S90-09/10
1609.1.2.2, Chapter 35

Proposed Change as Submitted

Proponent: John Woestman, The Kellen Company, representing the Door Safety Council (DSC)

IRC Figure R301.2(2)

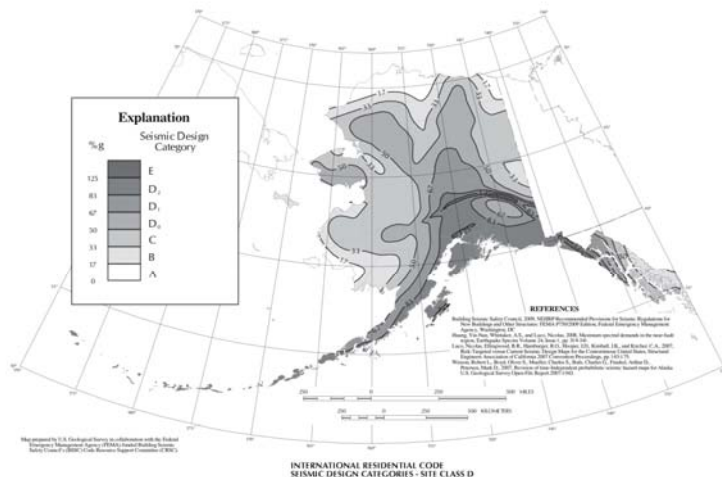
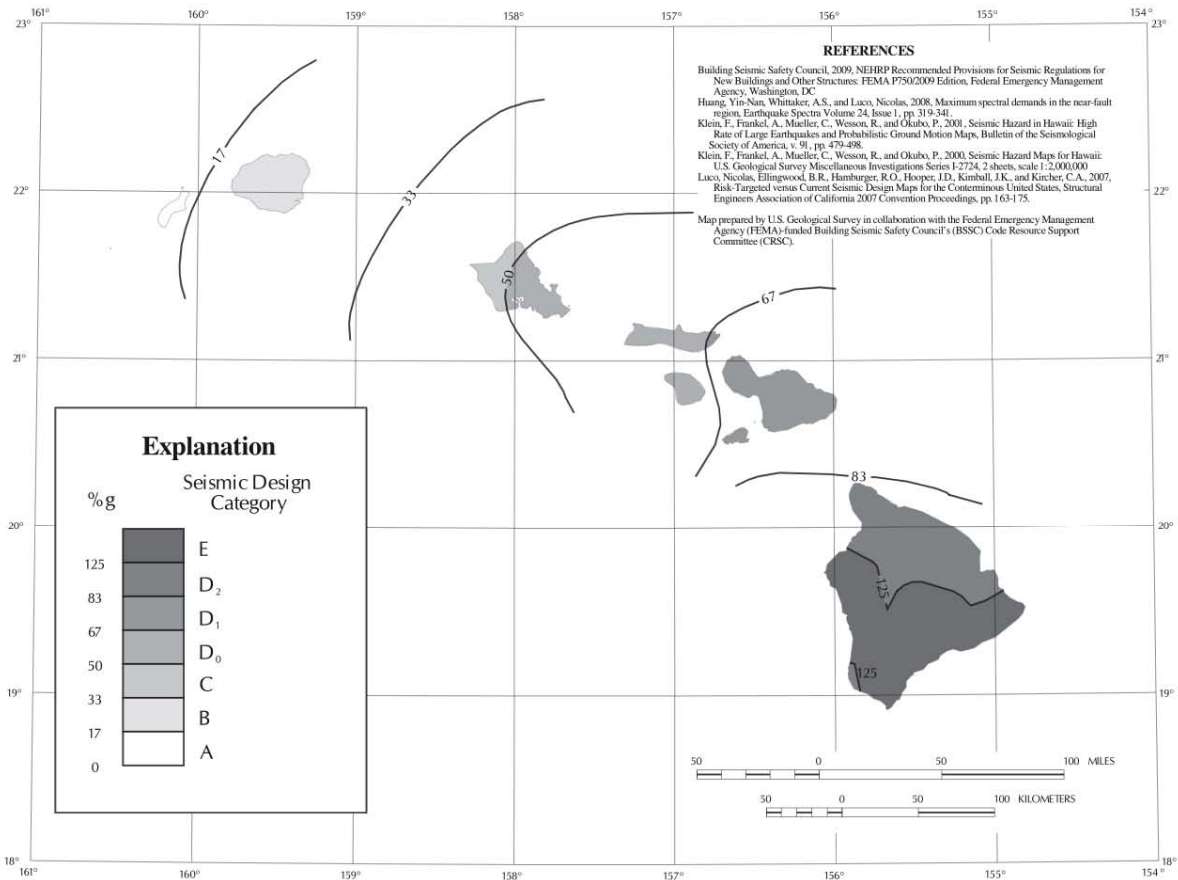
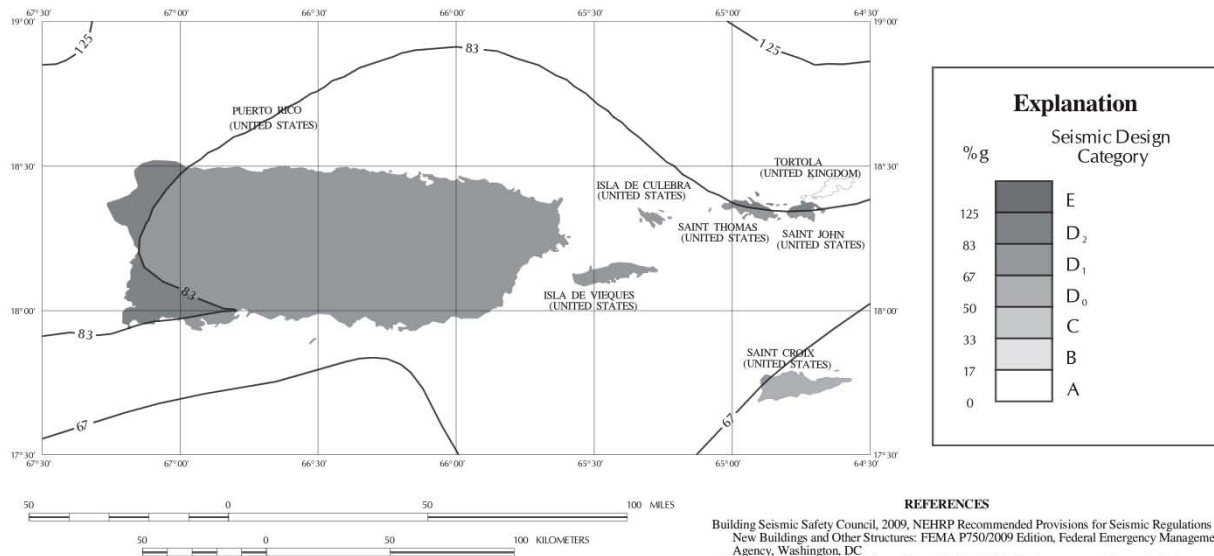
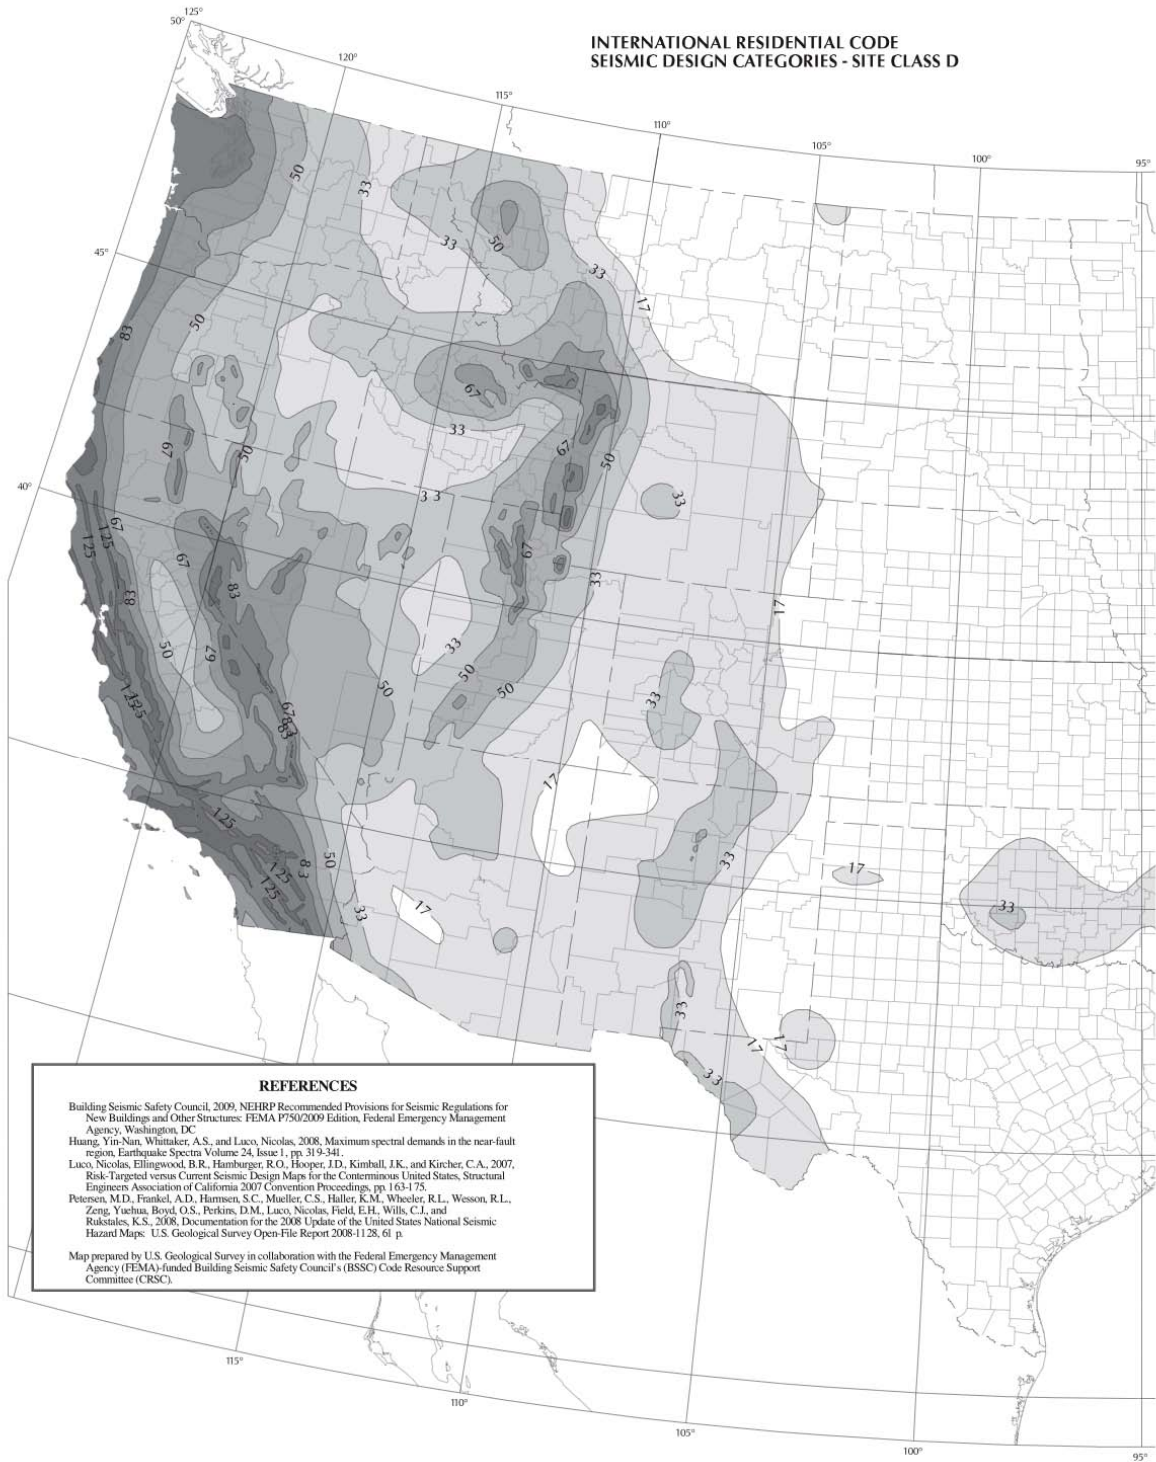
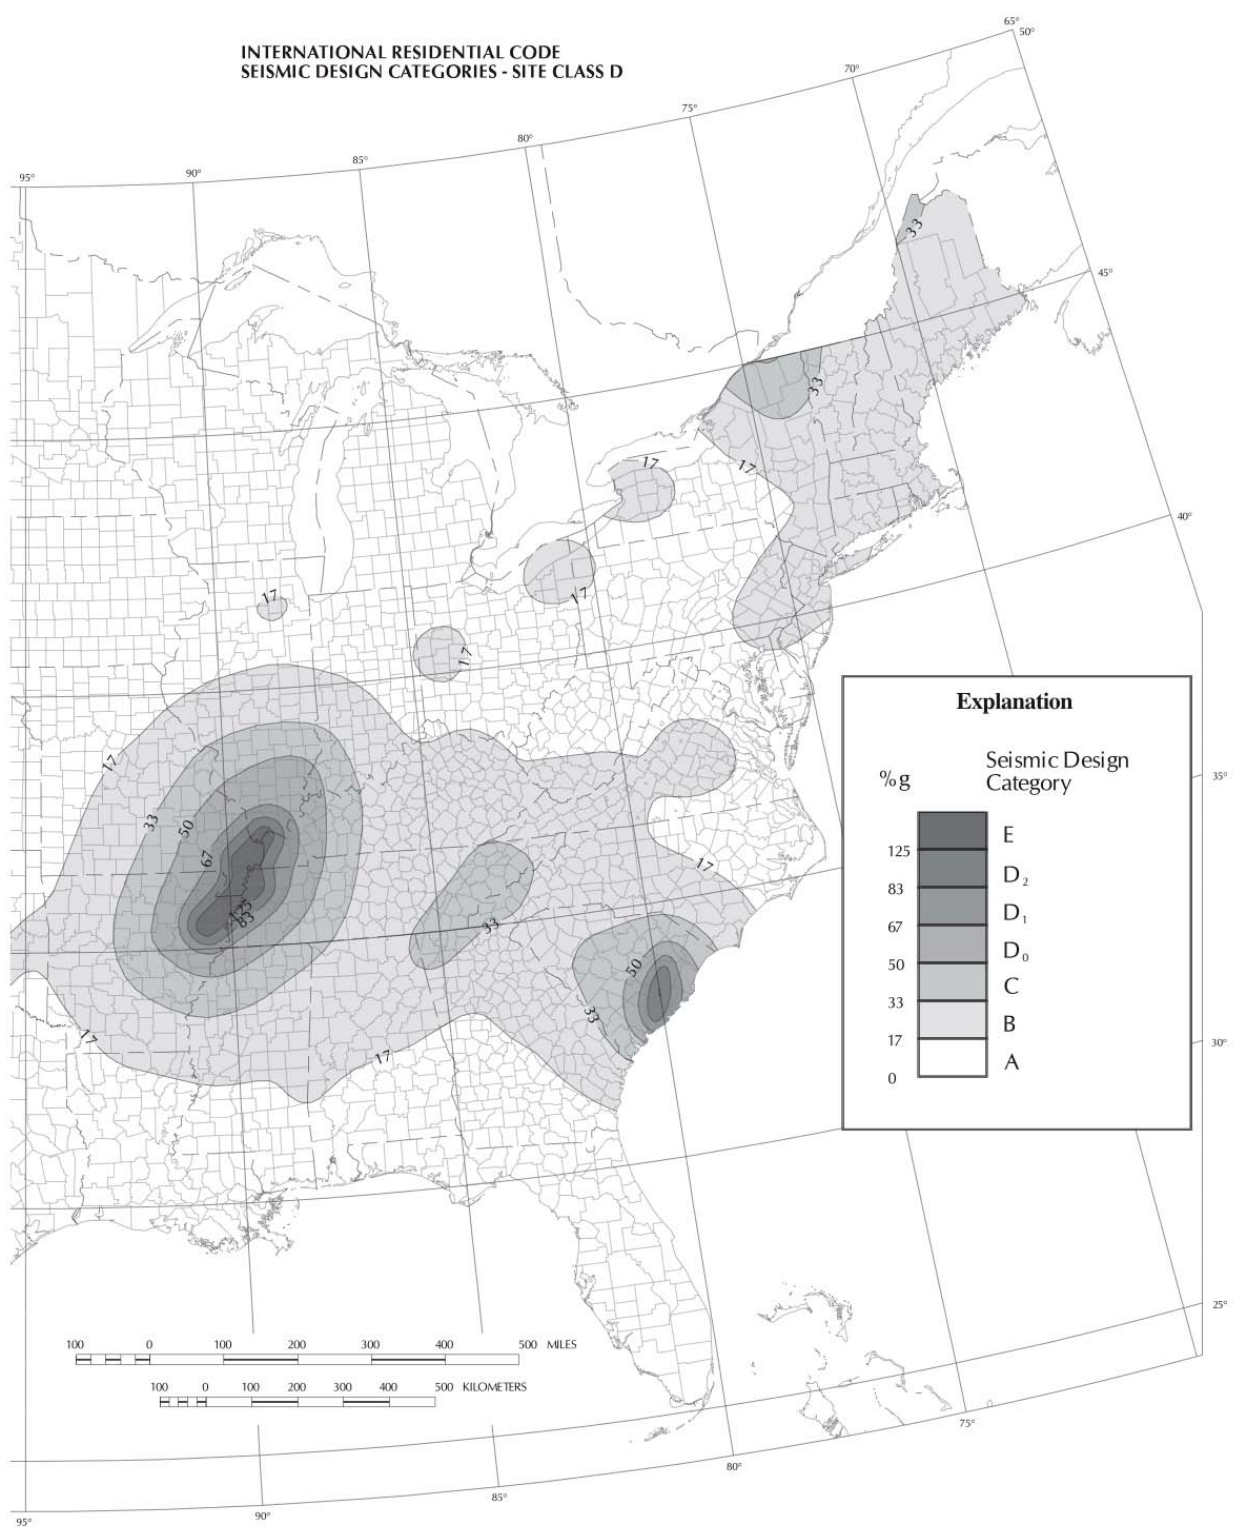
Reason: This proposal reflects new seismic hazard data developed by the U.S. Geological Survey (USGS) as part of its National Seismic Hazard Mapping Project and related technical changes developed by the Building Seismic Safety Council's (BSSC) Seismic Design Procedures Reassessment Group (SDPRG) as part of its work for the Federal Emergency Management Agency (FEMA).

These new IRC maps are different from earlier versions in that the division between Seismic Design Categories D2 and E has been changed from 118% g to 125% g. The 125% g contour would have been used in earlier maps but the mapping technology then available for drawing the IRC maps did not permit this to be done. The result of this change and the improved seismic hazard data generated by the USGS over the past 10 years is that the geographic region affected by the Seismic Design Category E designation is smaller. This occurs primarily in the region around Charleston, South Carolina, but is also evident in Seismic Design Category E regions in other parts of the United States. As noted above, maps developed on the same basis have been proposed for the IBC which will allow engineers to design components of the building that are outside of the scope of the IRC with compatible seismic loads.

Committee Reason: This change brings the latest and improved Seismic Maps into the code. This will correlate the maps with the IBC and ASCE 7-10. One benefit of the new map is that some Seismic Design Category E regions will be smaller in area. This will result in some previous Seismic Design Category E structures to now be Seismic Design Category D structures.

Figure A1 - Result of cycle test specimen 296 and 302

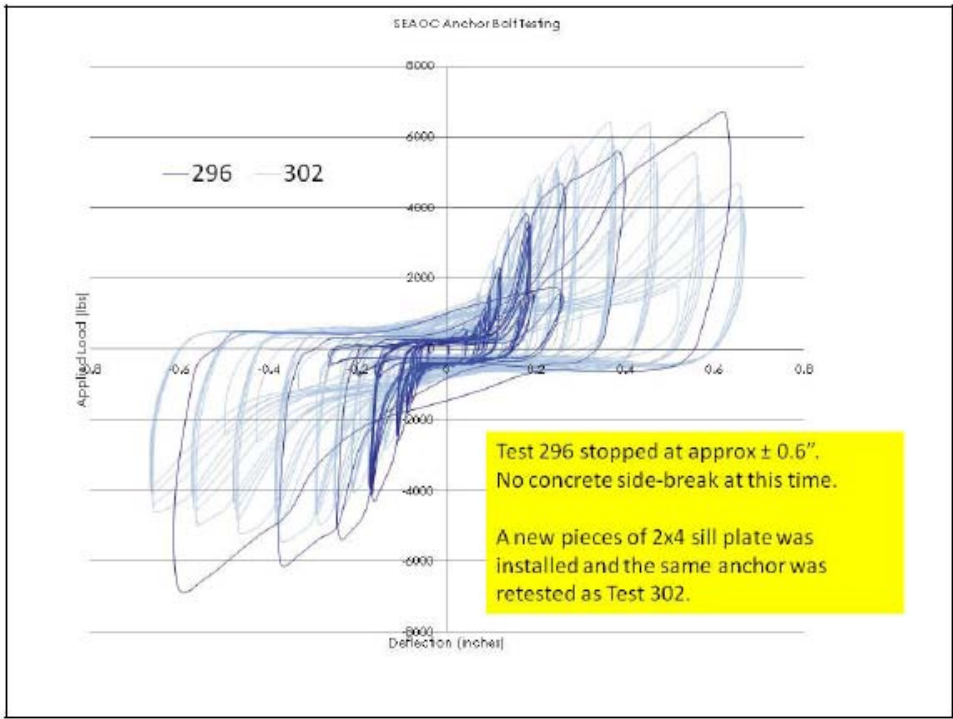
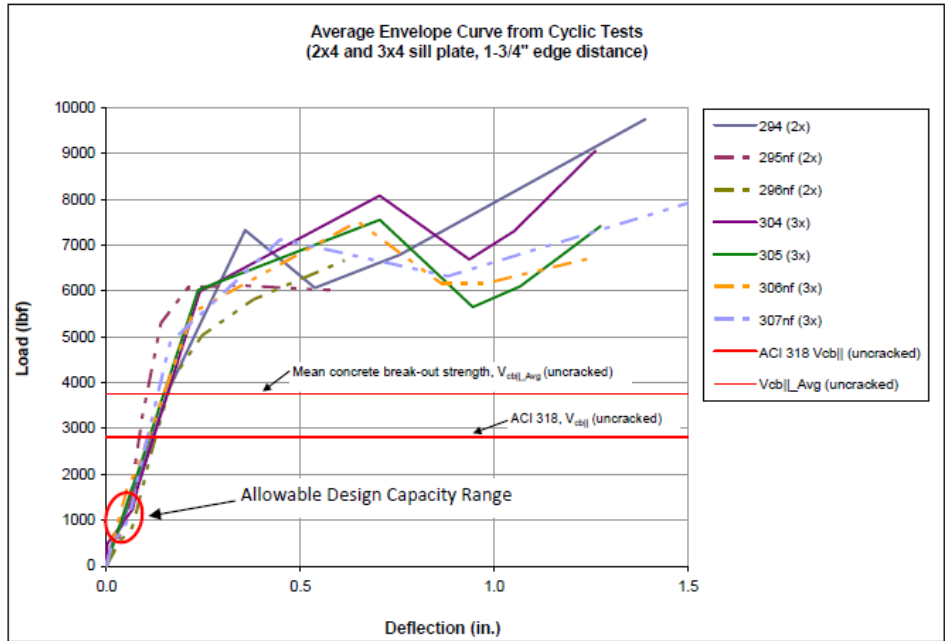
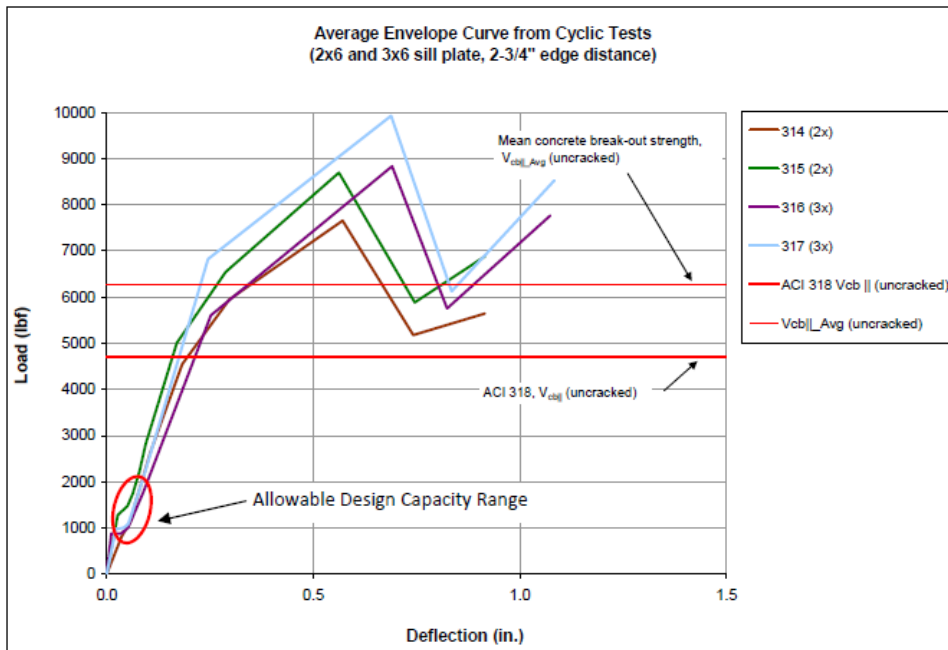
All cyclic test data was analyzed in accordance with ASTM E 2126 Standard Test Methods for Cyclic (Reversed) Load Test for Shear Resistance of Walls for Buildings. Result of cycle test of specimen 296/ 302 is shown in Figure A-1. The positive and negative envelop curves for each specimens were combined to produce an average envelope curve used to establish peak load, displacement at peak load, ultimate load, and displacement at ultimate load and summarized in Figures A-2 and A-3.

4. Cracking through the section did not occur at any point. For these reason, cracked section reduction appears overly conservative. It should also be noted that according to the available literature reductions are generally not required for shear anchorage applied perpendicular to a crack.

5. Test support design bolt values based on ACI 318 section D.3.3.3 using $0.75\Phi V_n$.
